Mango Tex Limited

23 September 2025

2. Observation:

Observation-01: High stress in the foundation, considering BNBC prescribed floor live loads, which requires immediate design review (Production Building).

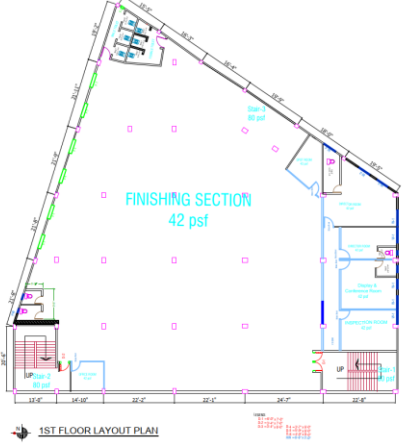
Description: Cursory calculation indicates high stress (bearing) in the pile foundation and isolated footing (amber marked), stress (bearing) in the foundation exceeds the normal design limit (yellow marked). Considering the allowable pile capacity of 454 KN (FoS- 2.50), the allowable soil bearing capacity is 11.46 Ton/m² (FoS- 3.0). Also, the punching shear stress of the foundation (red marked) exceeds the normal design limit.

For both cases, we considered the live load of 3 kPa for a typical floor, 6 kPa for storage, 5 kPa for stair areas, and a concrete strength of 15 MPa from the available core test report of the column. No concrete test report was available for retrofitting part of the column, but the core location was found.

The building engineer is required to take the following actions:

1. Verify the in-situ concrete strength of the footing. Also, confirm the concrete test report of the retrofitted column.
2. As part of the Detailed Engineering Assessment (DEA), review design, loads, foundation stresses, and suggest necessary remedial actions.
3. Produce and actively manage a loading plan according to the floor, column & foundation capacity.

Observation-03: Discrepancy/missing information in the as-built (Production Building).

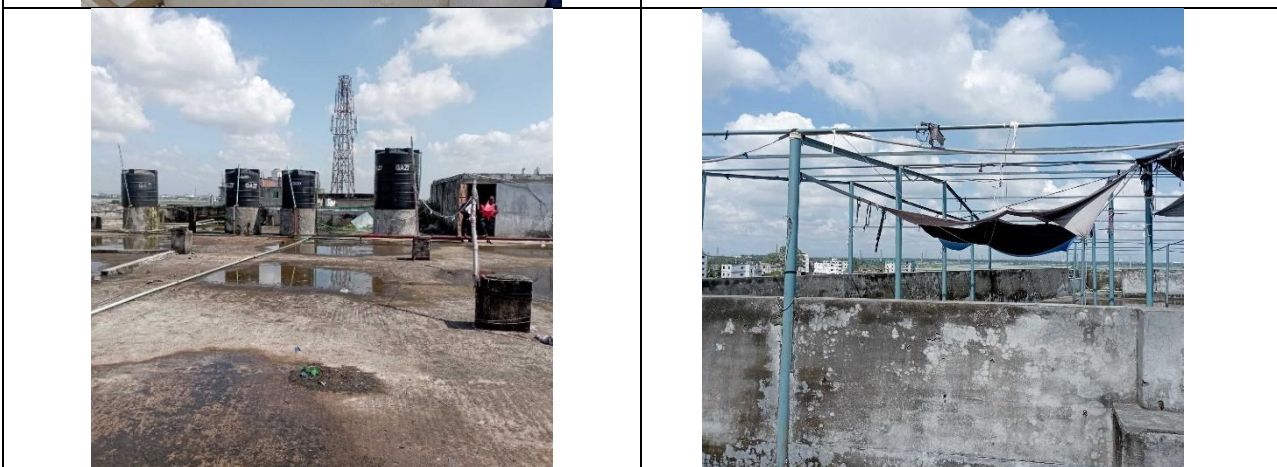
Description: Column C2 was found 500mmX375mm instead of 600 mm x 450 mm. Besides, some undocumented plastic water tanks and a steel frame were found on the roof. Also, the building has a basement, but no information was shown in the drawing. The building engineer is required to survey the whole structure and produce an accurate as-built drawing. Also, remove the undocumented steel frame.

Observation-04: Crack and dampness on the wall (Production Building).

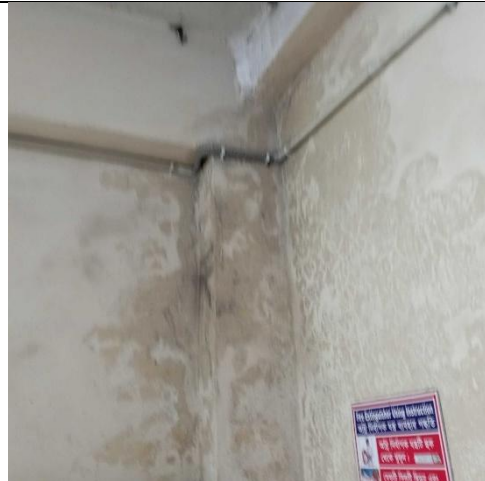
Description: Crack and dampness were found on the wall. The building engineer is required to repair cracks and dampness with a suitable method.

Observation-12: Inadequate member size and connection, Shed-3 (Security & Doctors' Room).

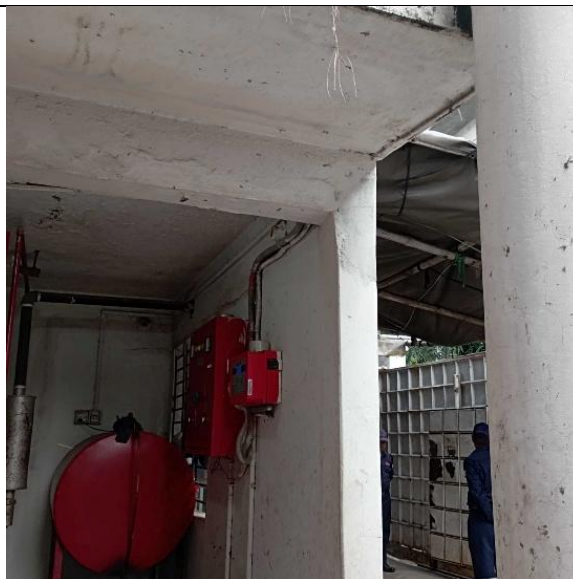
Description: Inadequate member size and connection were found. The building engineer is required to check the member and connection adequacy, submit it to RSC for review.
